BLOCK 136

LAND USE HEARING #2

JANUARY 22, 2015

Board-Formed Concrete - Revised

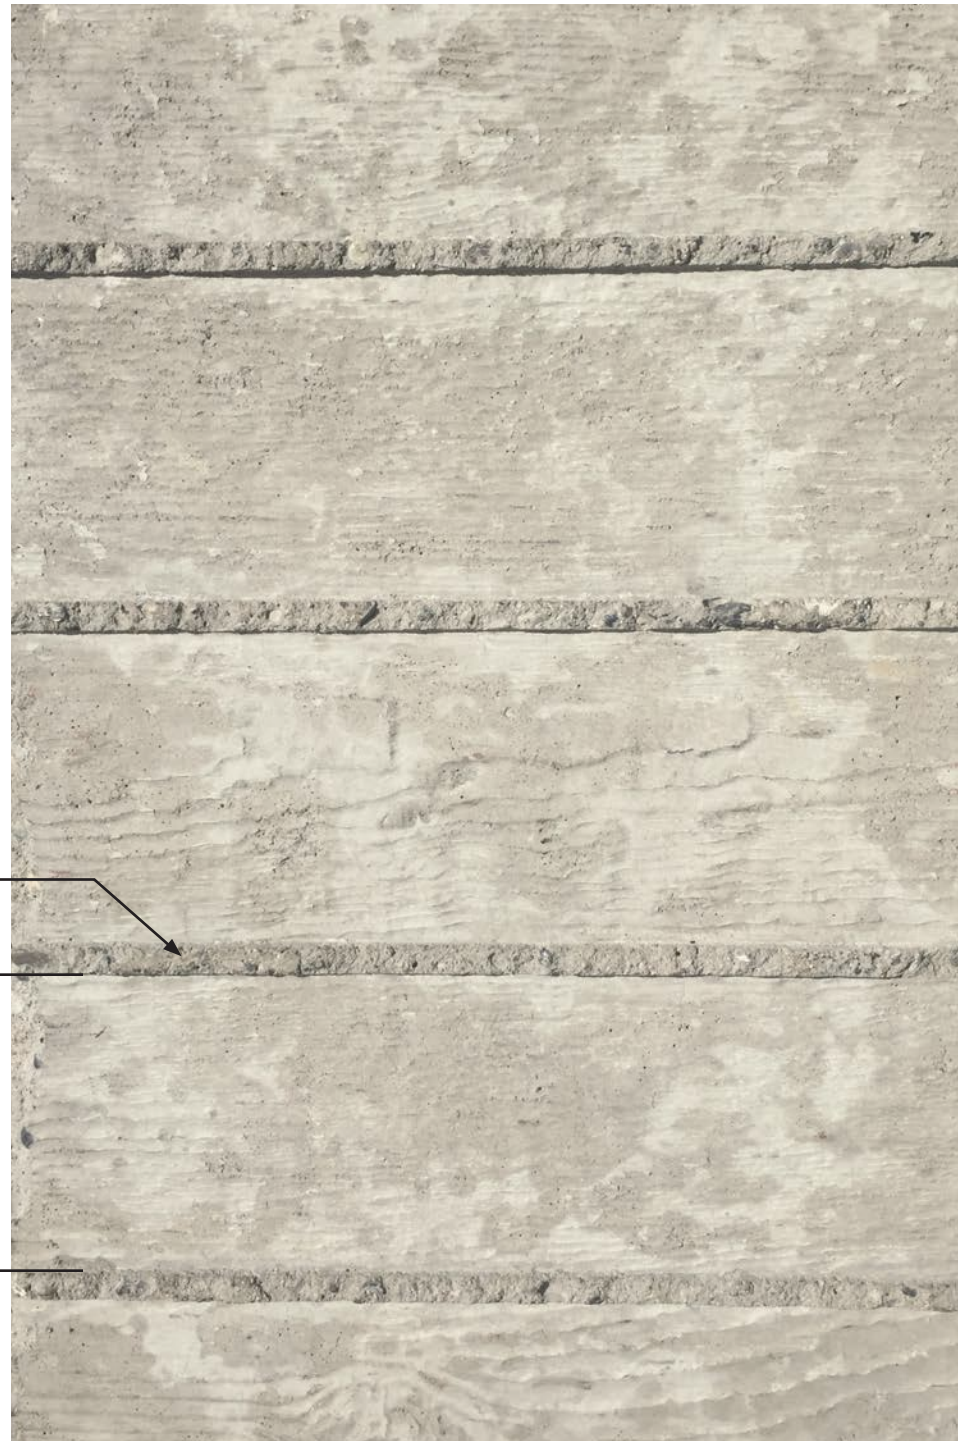
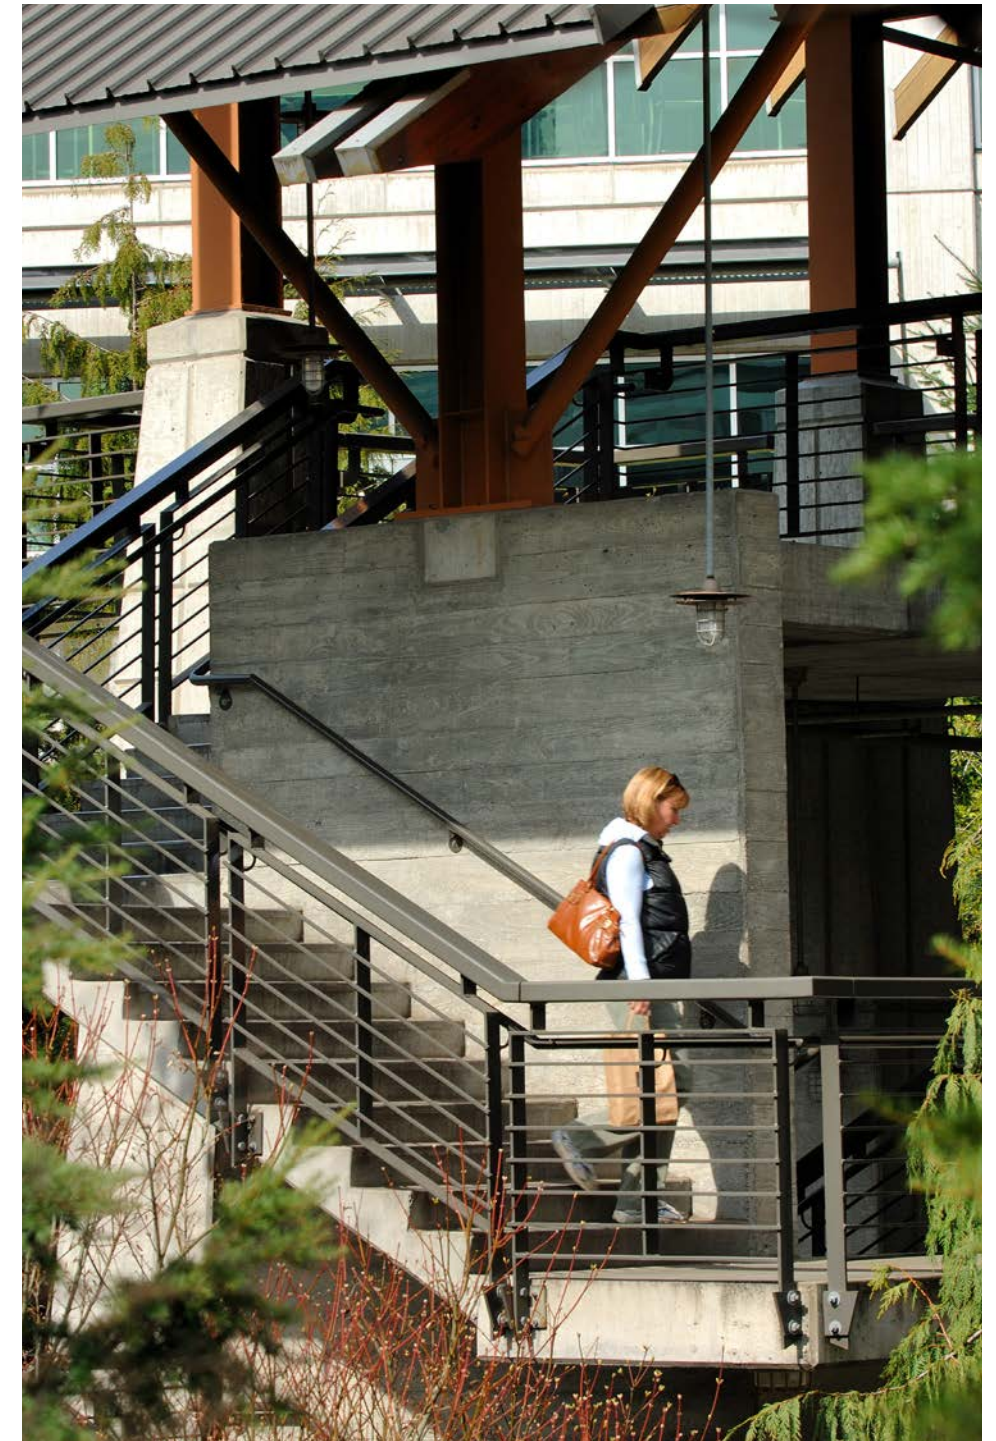
- Study corners at the southeast and southwest
- Add glass to townhouse canopies
- Describe board-formed concrete finish
- Study if residential entry canopy is too low
- Consider increasing the depth of the northern balconies

- Formed with highly-textured salvaged lumber (no formliner)
- 2x6 boards, horizontally laid
- Gaps between boards to achieve raw horizontal lines
- Mock-up using garage walls until desired look is achieved

1/4" gaps between form boards to create rough, protruding ribs

Salvaged form boards:
2x4 shown
2x6 proposed

Dock Canopies - Revised

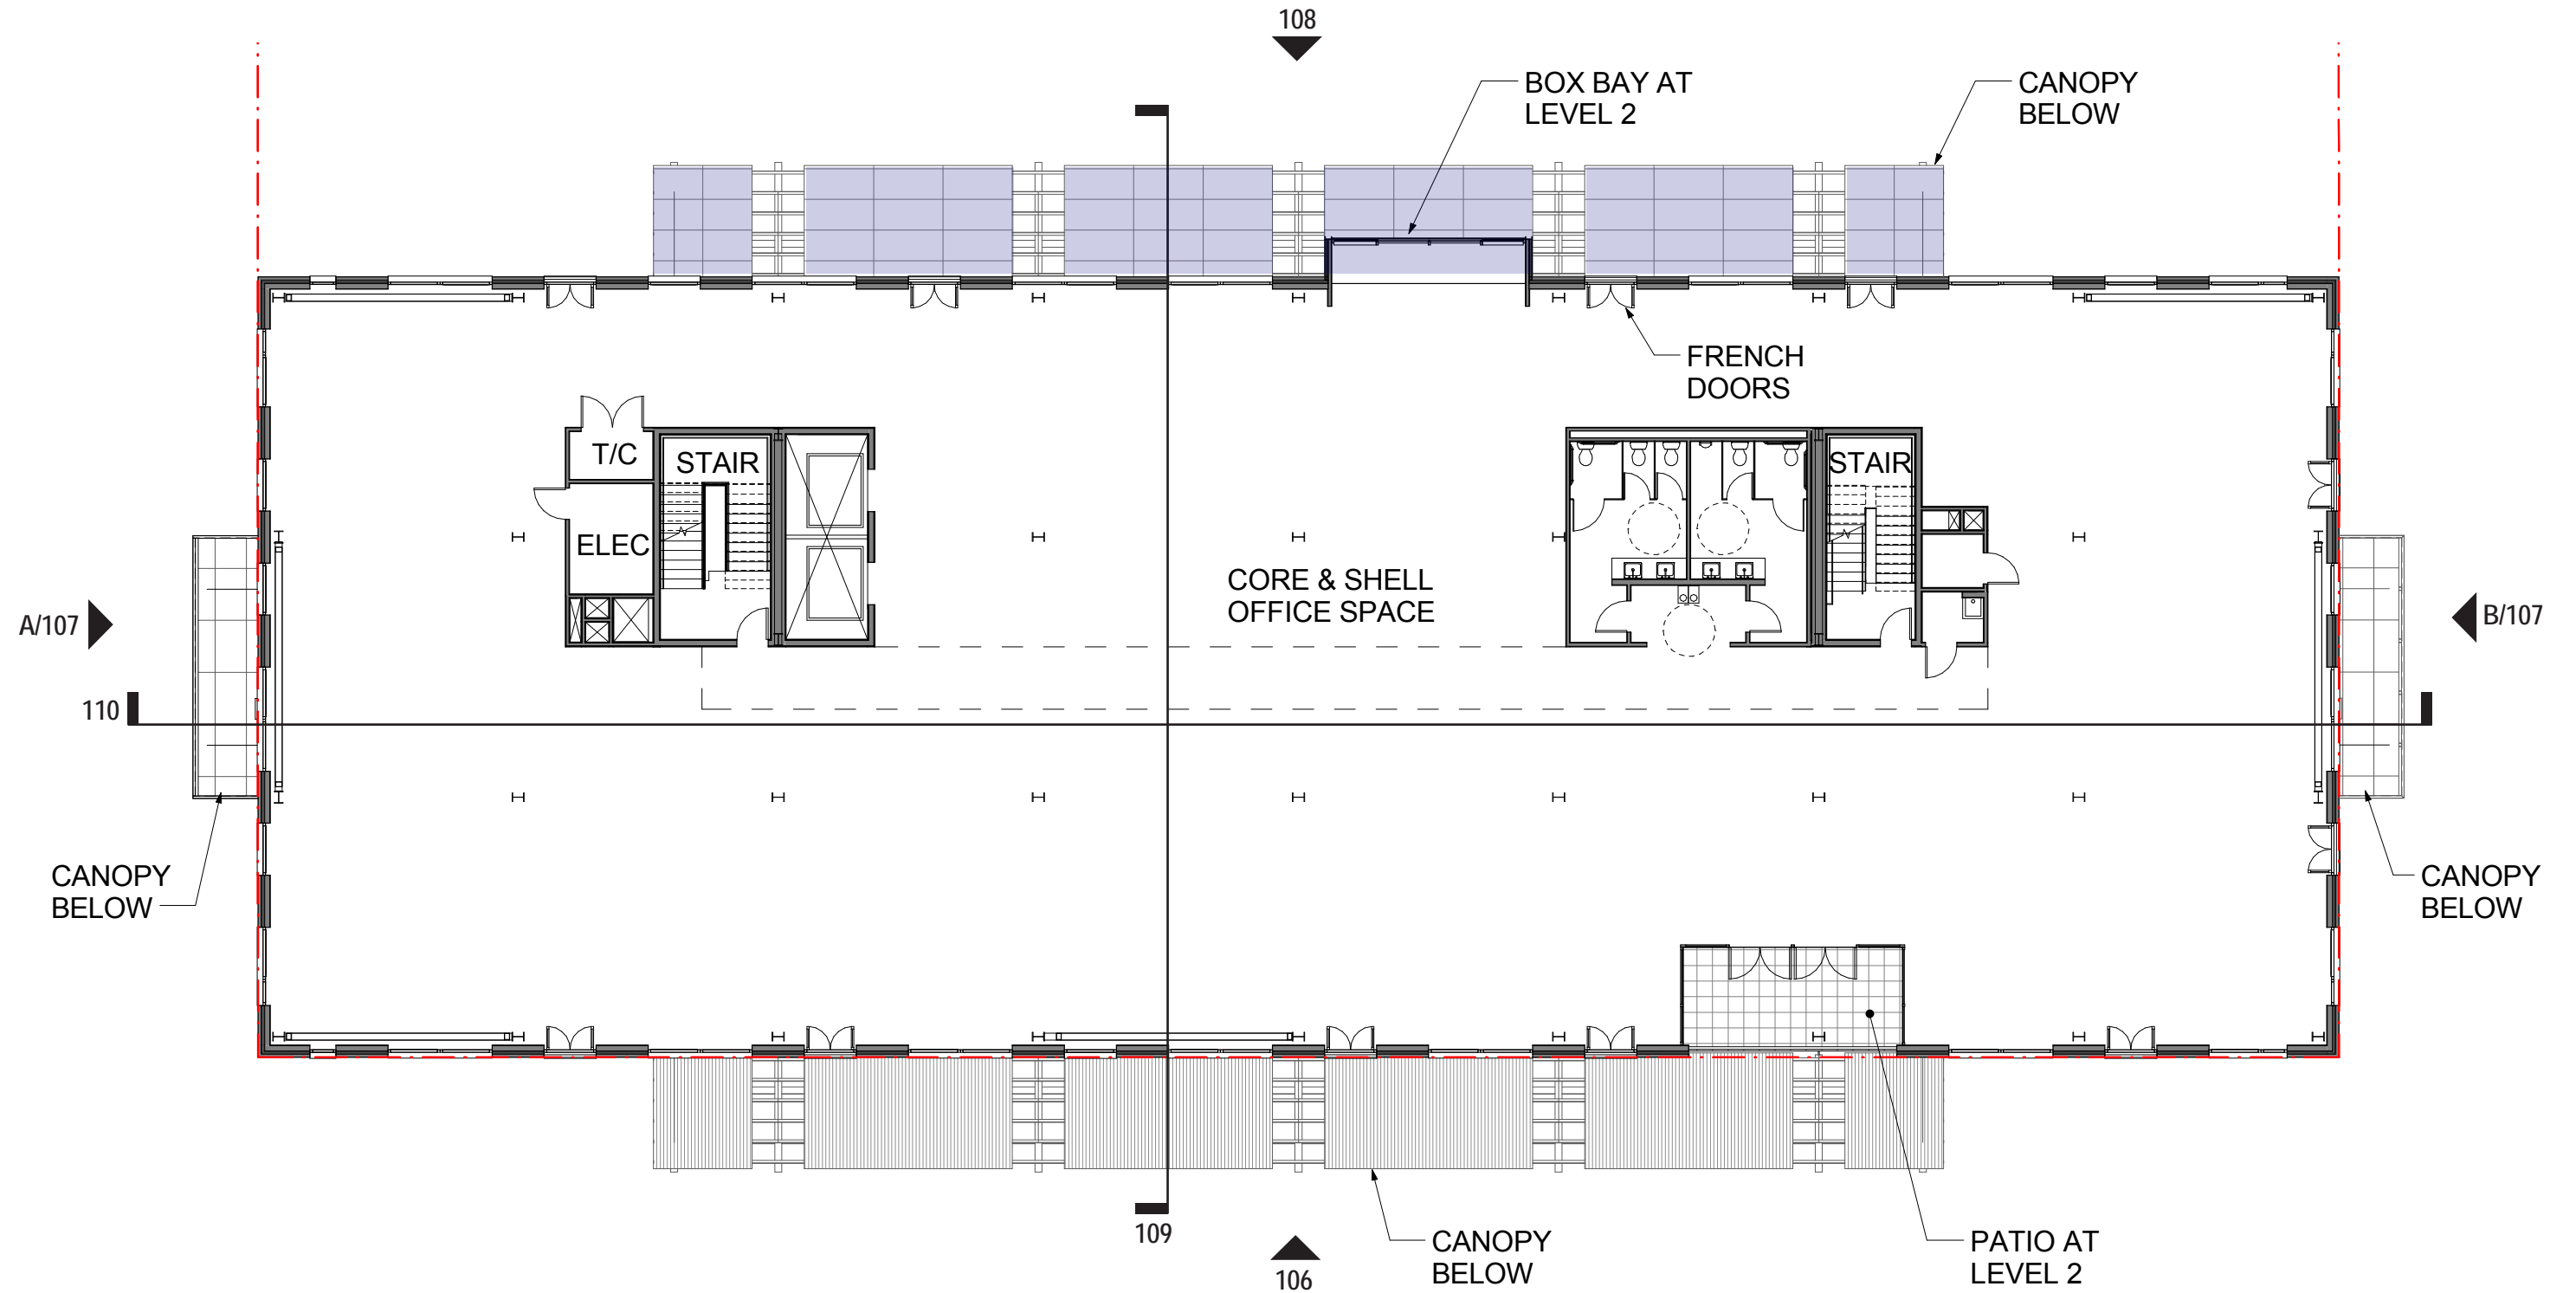
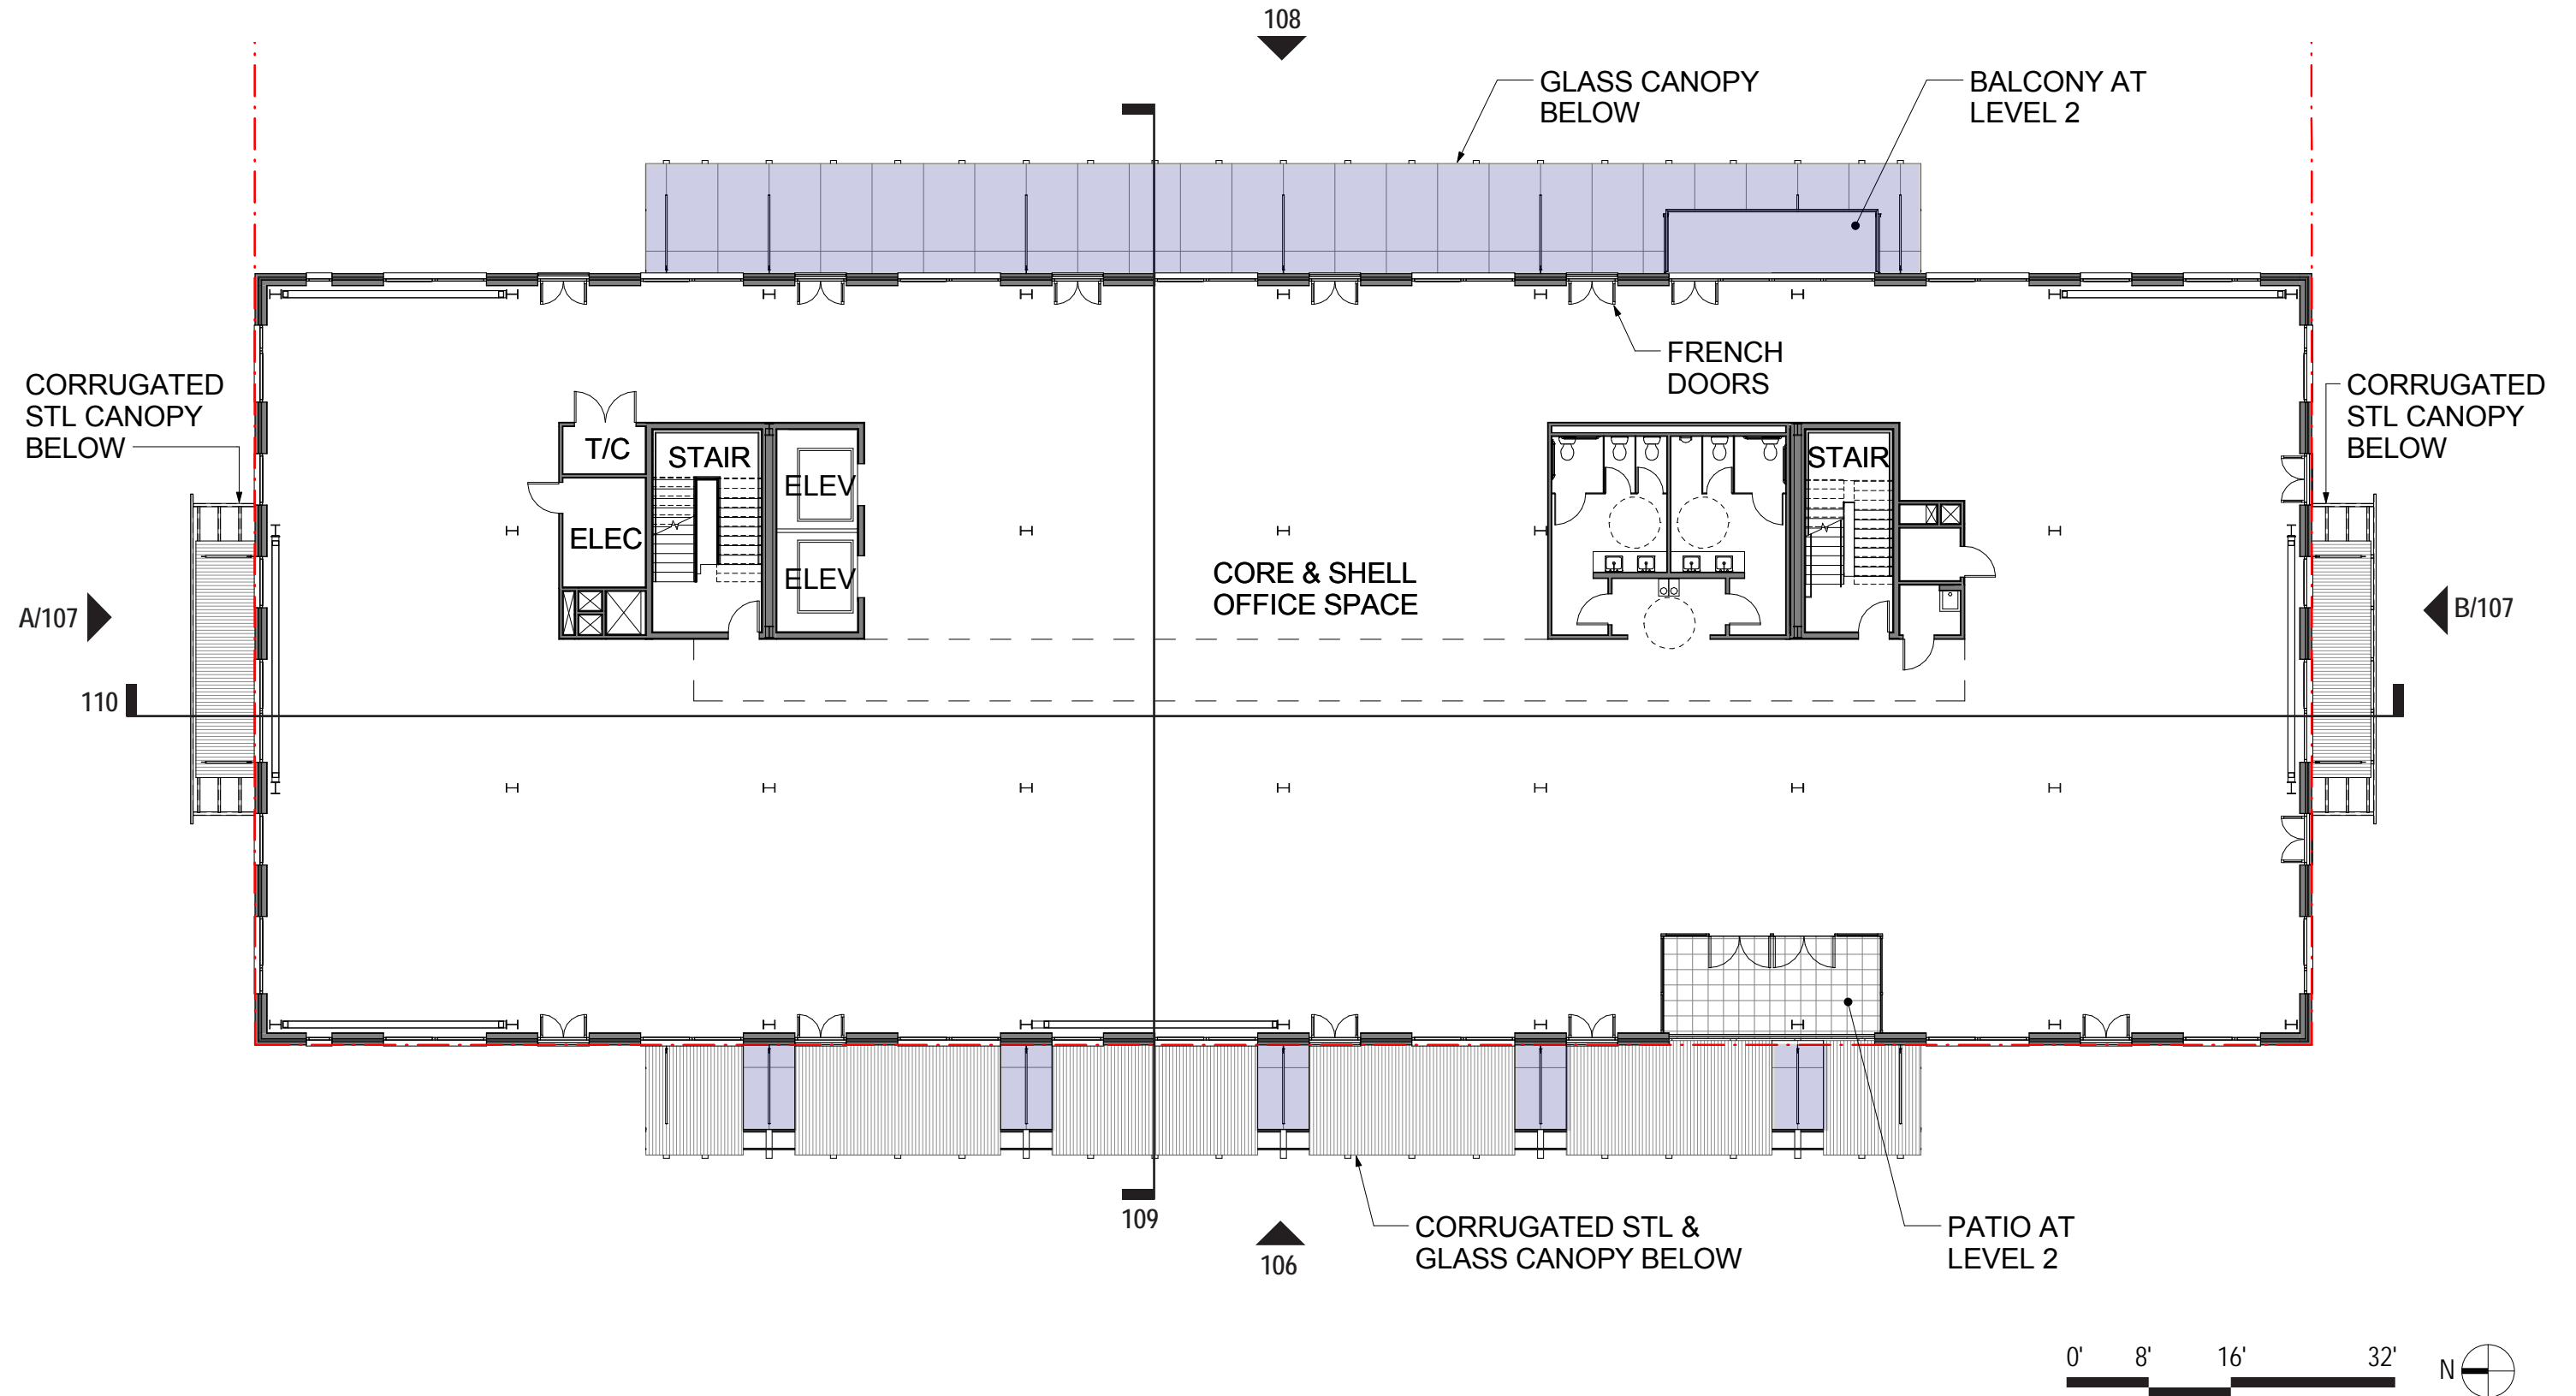
- Revise canopies to have continuous weather protection
- Study the removal of the bays on the east facade
- Study the detailing and play of light on the brick
